ADDENDUM NO. 3
10/21/2019

NEW PORTABLE CLASSROOM BUILDING
Camarillo Academy of Progressive Education

PBK Project No.: 191726

ADDENDUM NO.3 - AD-3.0

REVISED DRAWING: 1 / A0.01

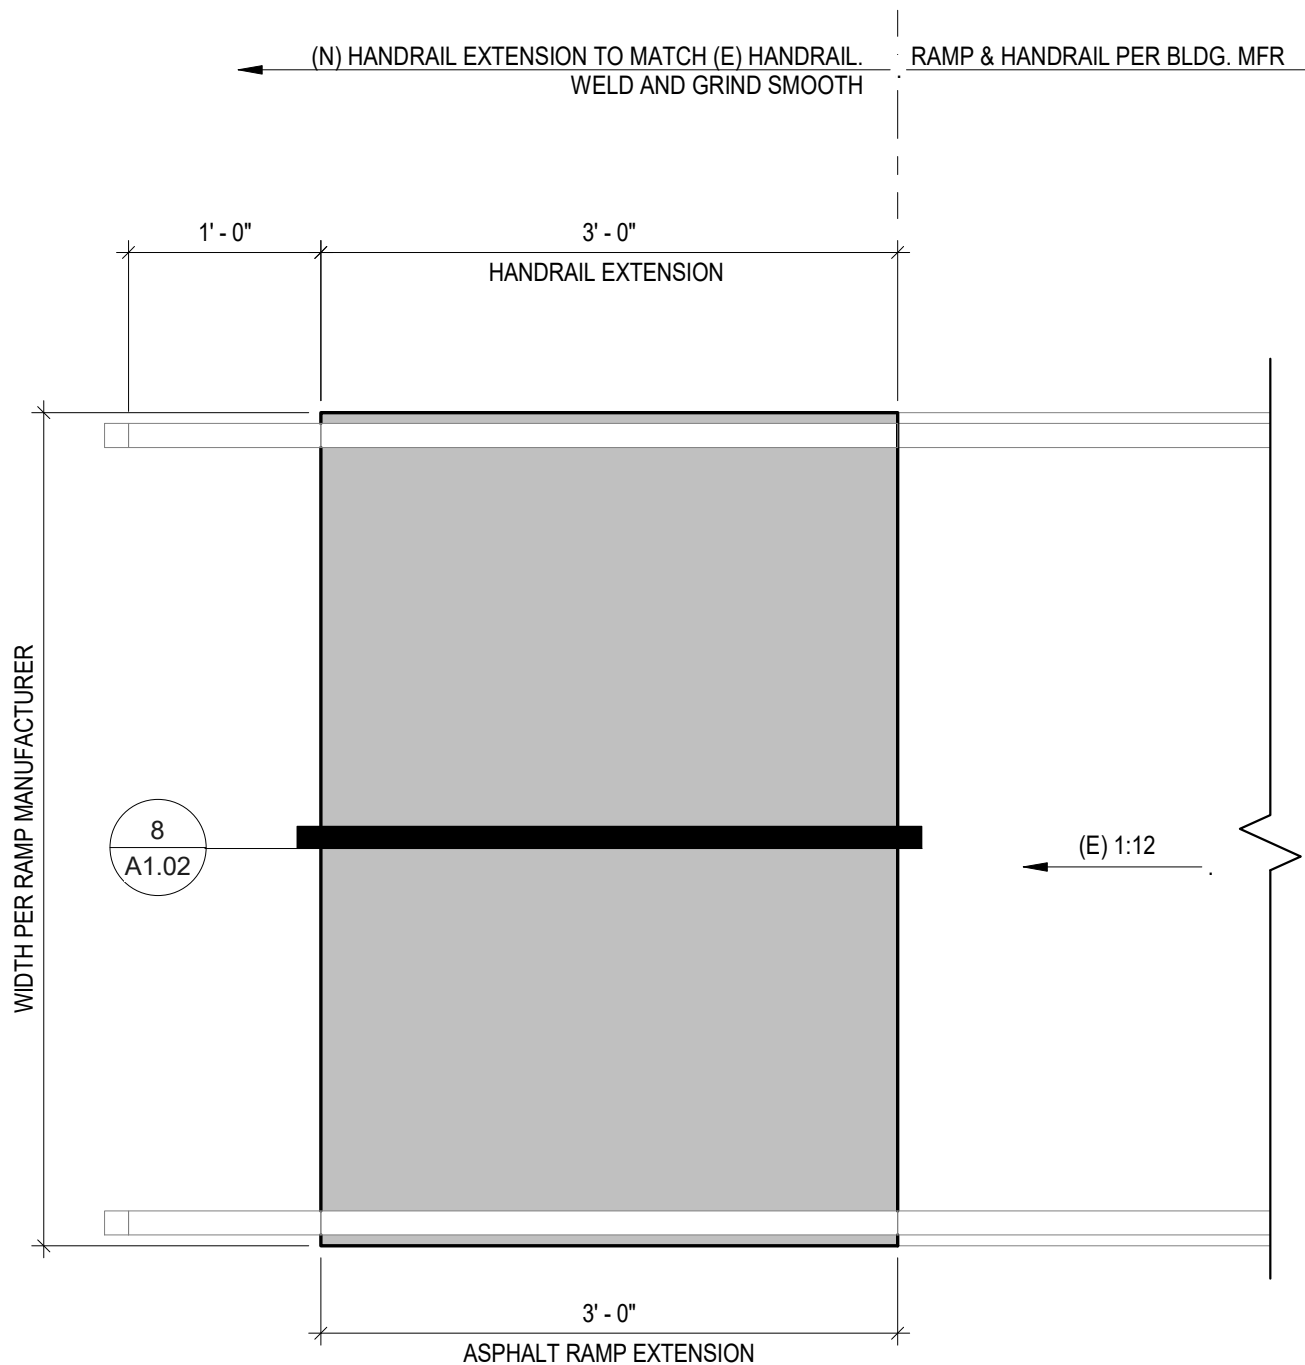
1. AD-3.1 Enlarged Site Plan
A) See attached for updated Enlarged Site Plan (1/A0.01) and added keynote 32.05 for ramp extension.
2. AD-3.2 Handrail Extension at Manufacturer Ramp – Plan View
A) See added detail #7 to sheet A1.02.
3. AD-3.3 Handrail Extension at Manufacturer Ramp
A) See added detail #8 to sheet A1.02

Key	Note
00.01	(N) PORTABLE BUILDING PROVIDED BY OWNER. REFER TO MANUFACTURER DRAWINGS AND SPECIFICATIONS FOR MORE INFORMATION
00.02	(N) RAMP AND LANDING SYSTEM PROVIDED BY OWNER. REFER TO MANUFACTURER DRAWINGS AND SPECIFICATIONS FOR MORE INFORMATION
02.11	PROTECT IN PLACE (E) BENCH
32.01	(N) CHAINLINK FENCE. REFER TO DETAIL 5 ON SHEET A1.02 FOR MORE INFORMATION AND COORDINATION.
32.02	(N) CHAINLINK FENCE GATE. REFER DETAIL 5 ON A1.02 FOR MORE INFORMATION
32.05	(N) PORTION OF ASPHALT RAMP EXTENSION. REFER TO 7/A1.02 FOR MORE INFORMATION

RESPONSE: Please refer to clarification sketch AD-3.1, AD-3.2, AD-3.3.

ADDENDUM NO.3 - AD-3.4

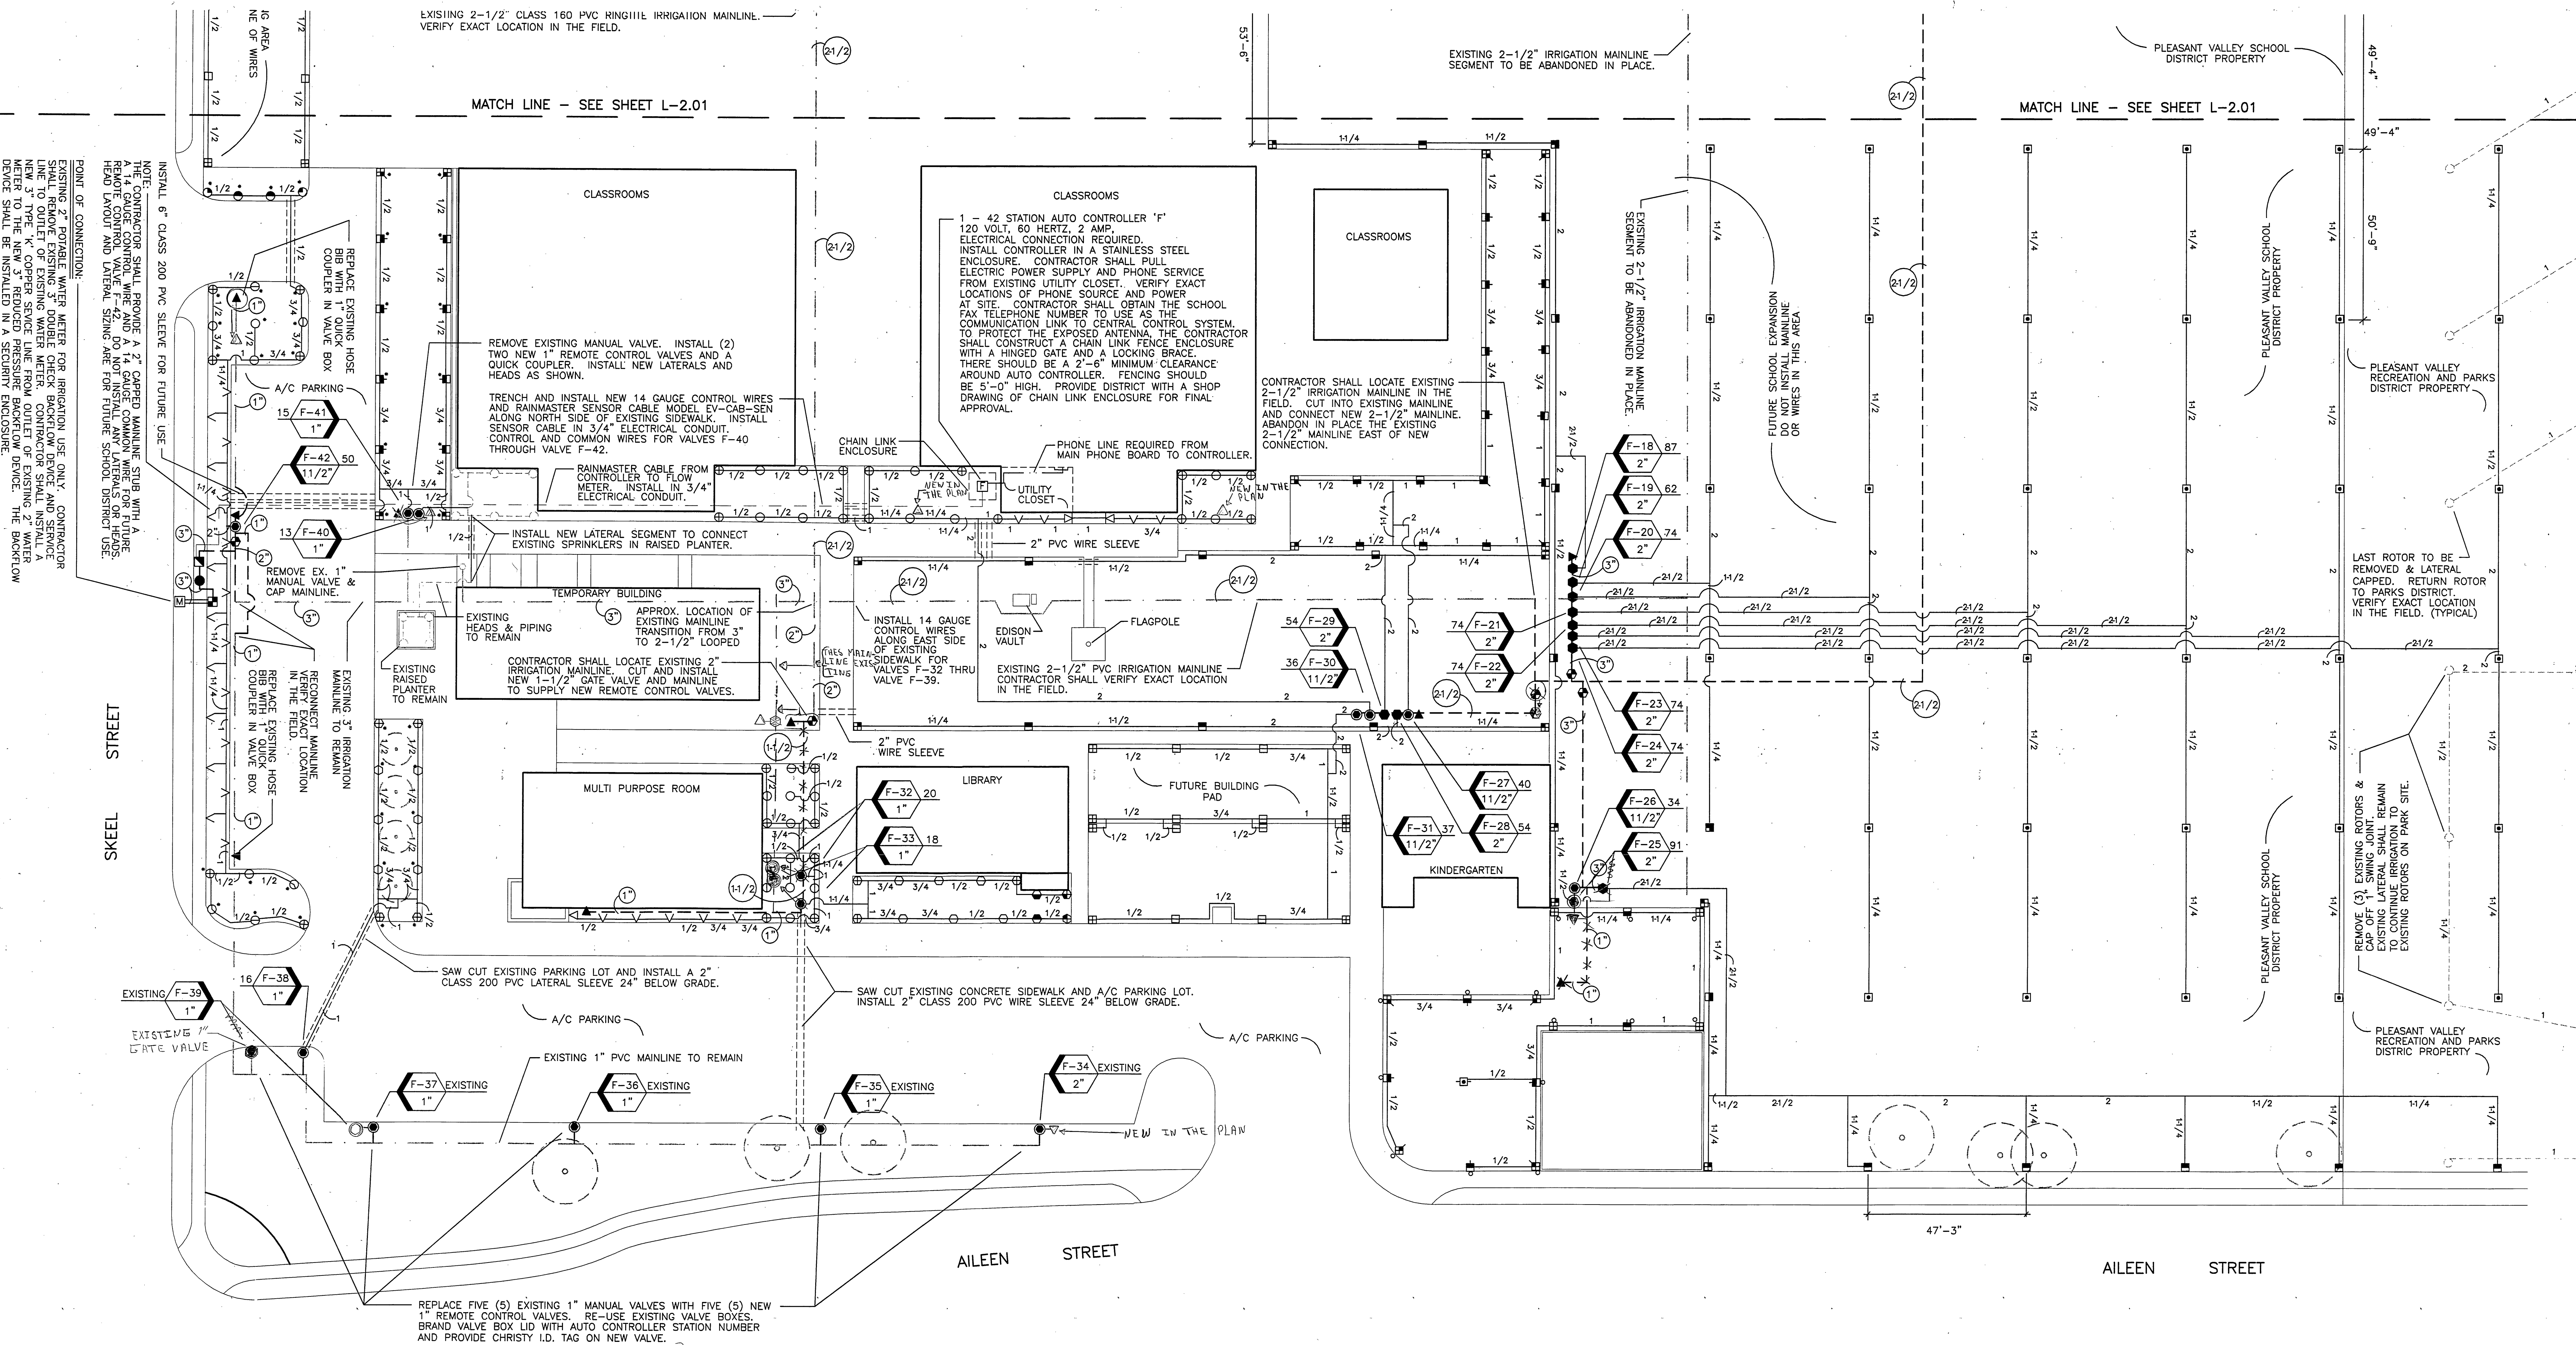
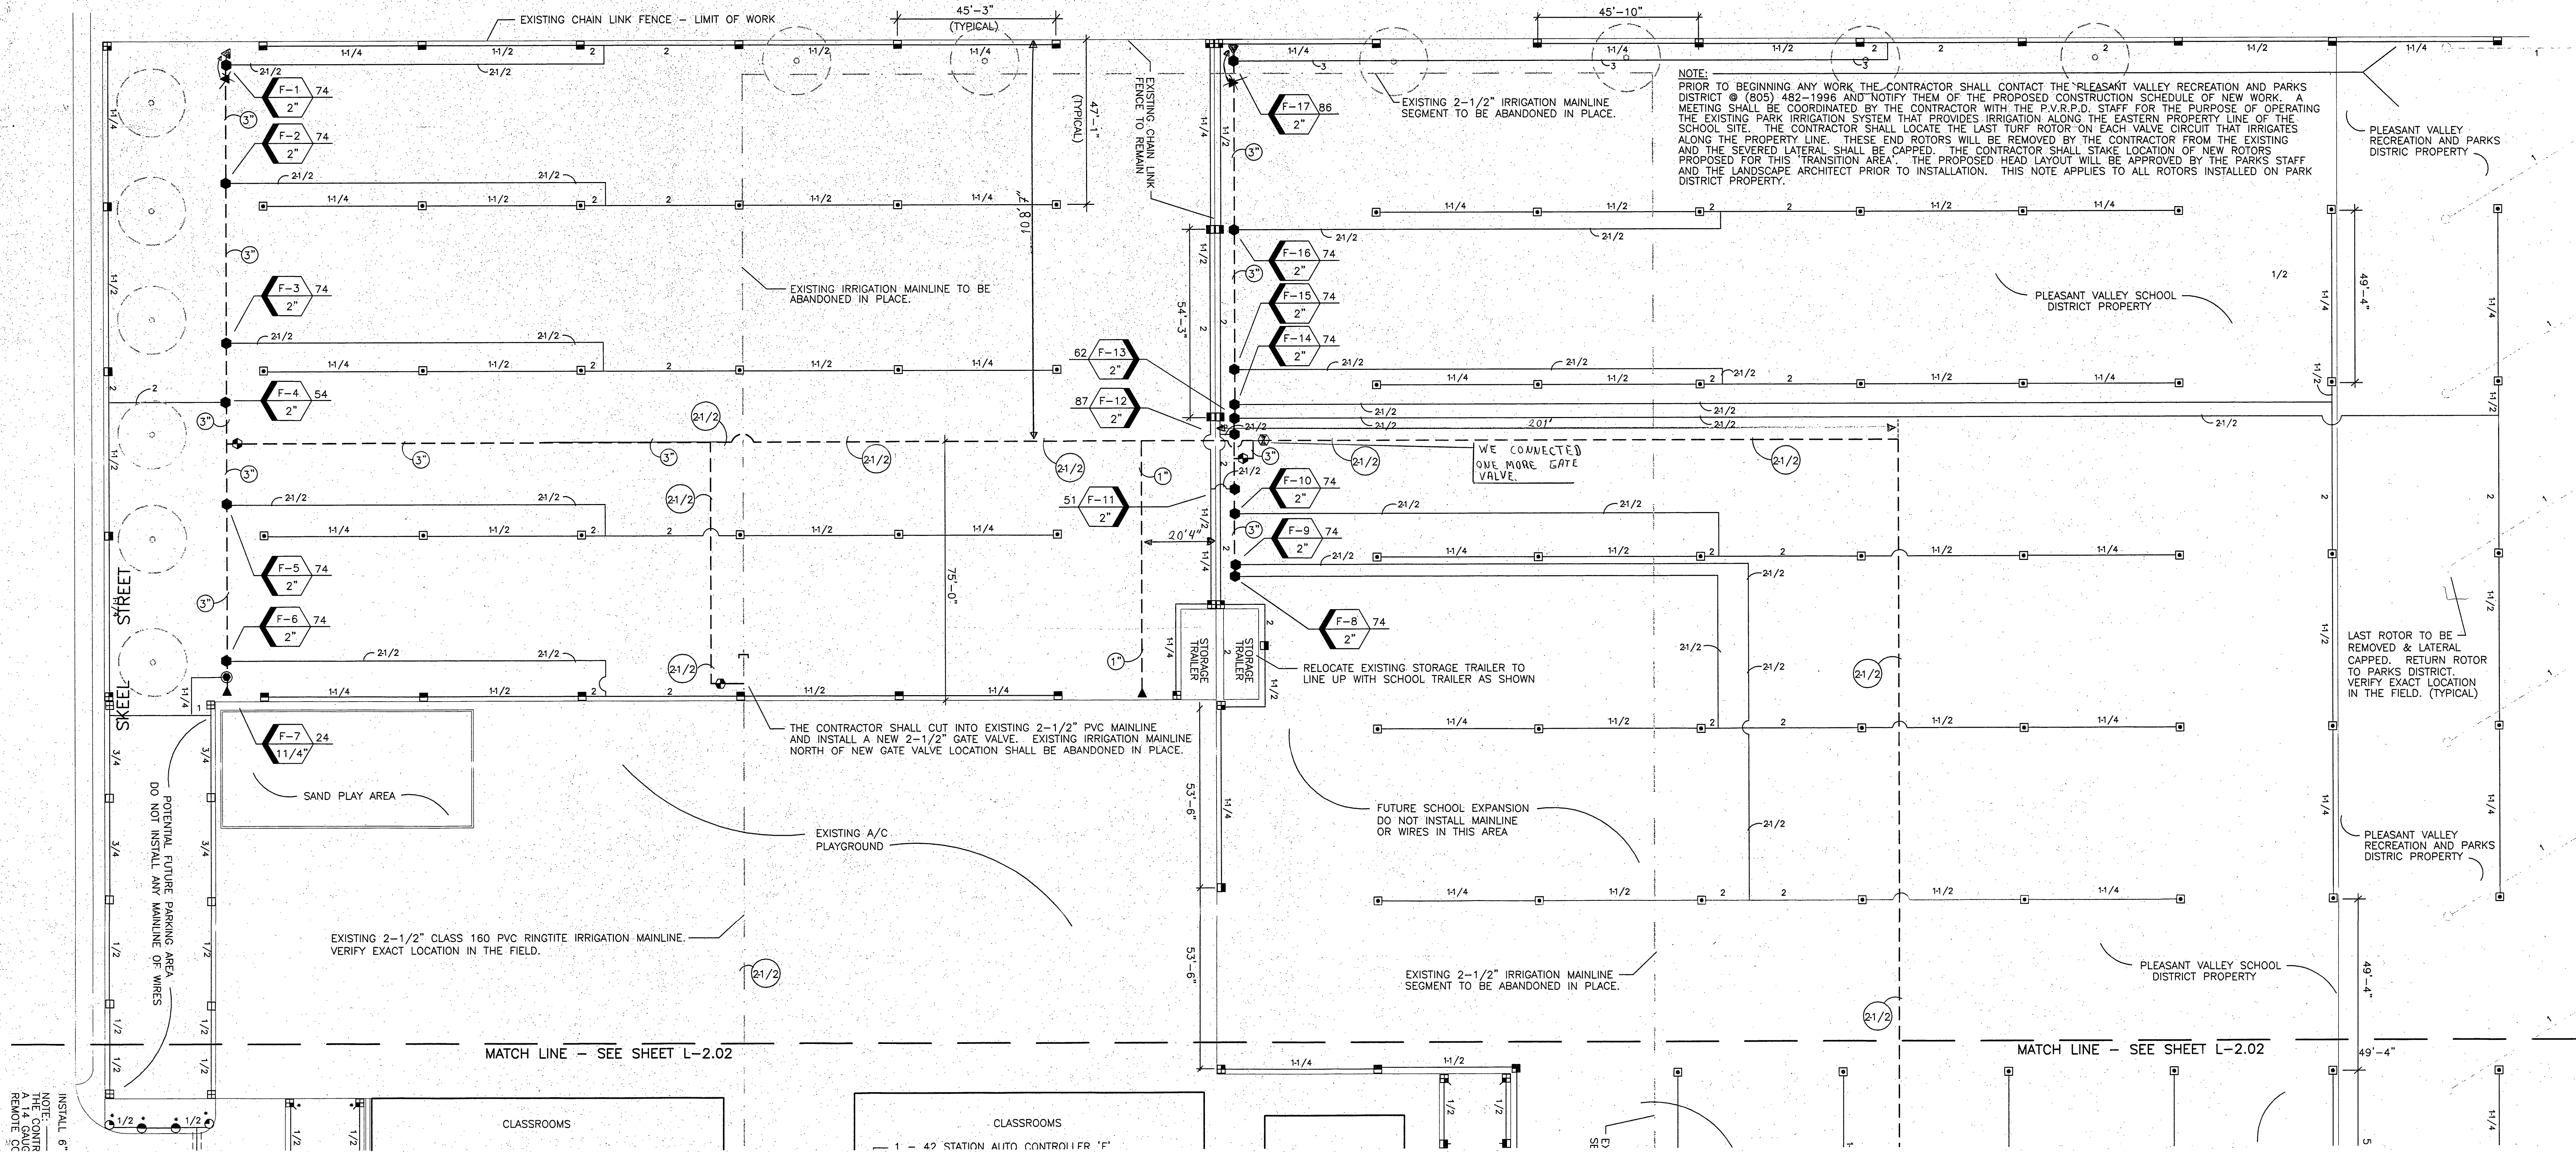
4. AD-3.4 Landscape and Irrigation Record Drawings
A) See attached for landscape and irrigation record drawings.

5. During the site walk it was noticed allot of irrigation valves that will impact the project. Does the District know the lines location? Will the District cap off the lines under the new project?

RESPONSE: Contractor is responsible to cut and cap existing sprinkler lines that are affected by new construction. See attached drawings for approximate irrigation system layout and coordinate with Owner prior to irrigation system modification.
